COUNTY OF YORK

MEMORANDUM

DATE: March 11, 2022 (HYDC Mtg. 3/16/22)
TO: Historic Yorktown Design Committee
FROM: Earl W. Anderson, AICP, Senior Planner
SUBJECT: Application No. HYDC-215-22; Watermen's Museum, 309 Water Street

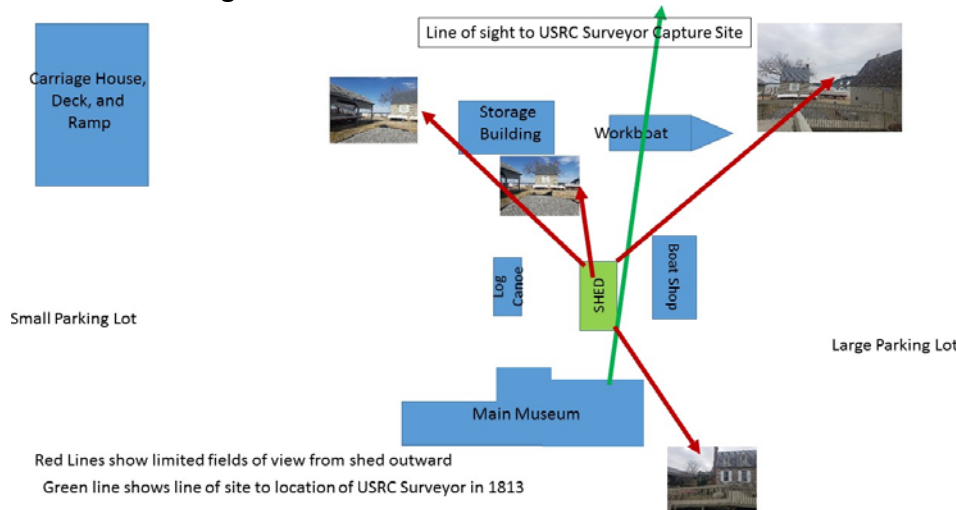
<p>d. Roof Shapes</p> <p>(1) Roof shapes should be a traditional gabled style with a slope consistent with those found on pivotal and contributing buildings throughout the village. Roof shapes and orientation should be designed with consideration given to maintaining views and visibility from the bluffs and other significant vantage points.</p>	<p>The shed is proposed to have gambrel style roof. This roof style is seen on other structures in the village and would complement the adjacent structures. The location of the proposed shed would maintain existing views.</p>
<p>e. Design</p> <p>(1) Overall building design should be consistent with the character of Yorktown and particularly the style, shape and massing of the buildings on Main Street.</p>	<p>The shed design is consistent with other types of sheds and structures within Yorktown.</p>
<p>f. Sense of Entry/Orientation</p> <p>All primary buildings should have an orientation and entrance to Water Street. Buildings on parcels located between Water Street and the York River should also have a façade developed to orient to the river. Entries should be articulated with covered porches, porticos or other pronounced architectural forms.</p>	<p>The shed will not be the primary building on the site and will be behind the main museum building with the door oriented away from Water Street.</p> <p>The barn style door and porch proposed for the shed match the form outlined.</p>

Architectural Elements	
<p>a. Walls</p> <p>(1) Wall materials should be compatible with those of existing construction in type, color, texture, size, spacing, and general appearance. Weathered,</p>	<p>The walls of the proposed shed will have clapboard siding, which is an acceptable material. The applicant has proposed to paint the structure to match the colors</p>

<p>c. Doors</p> <p>Windows in entrance doors are permitted and should be vertically proportioned. Exterior doors should be of painted wood, enameled metal, or glass. Sliding glass doors should not be used.</p>	<p>The proposed door is painted wood.</p>
<p>d. Windows and Shutters</p> <p>(1) Window openings should be designed to respect the width to height ratio of the bays in the building façade. Attention should be given to the façade's overall composition, symmetry, or balanced asymmetry. Windows should be square or vertical in proportion. Casement windows should be avoided.</p> <p>(2) Windowless elevations visible from Water Street, the river, or public spaces should be avoided.</p>	<p>Windows are sized proportionally to the structure size and balance the symmetry.</p> <p>The windows were not noted, but casement windows should be avoided.</p> <p>The structure has windows.</p>
<p>e. Roofs</p> <p>(1) In general, roofs should be of a symmetrical gable style. Primary roofs should have slopes no less than 9:12. Secondary roofs may have slopes less than 9:12 depending on the material used (e.g. – a standing seam roof over a porch might have a lesser slope).</p> <p>(4) Roof materials should be wood or asphalt/fiberglass composition shingles, or cement shingles. Shingle colors should be compatible in color with the exterior color of the building, either existing or as selected from the Yorktown Color Palette, as defined in Appendix 3, Glossary.</p> <p>(5) Roof vents, chimney caps and plumbing vents shall match the color of the roof or shall be black, dark gray, or copper/bronze.</p>	<p>The proposed roof is a gambrel style. The slope of the proposed shed is not noted, but appears to match that of other gambrel roof designs and should not be a prominent feature with the property.</p> <p>Charcoal grey architectural shingles are proposed.</p> <p>The photographs submitted shows no vents being used on the roof.</p>

1. The shed shall be constructed in accordance with the exterior features depicted on the photograph and with the supplementary information detailing proposed materials and colors presented with the application and received March 1, 2022.
2. The orientation of the shed shall have the door facing away from Water Street.
3. Trim should be made of trim-grade lumber, not to exceed 2 inches in actual thickness, 6 inches in width at corners and 4 inches around openings.
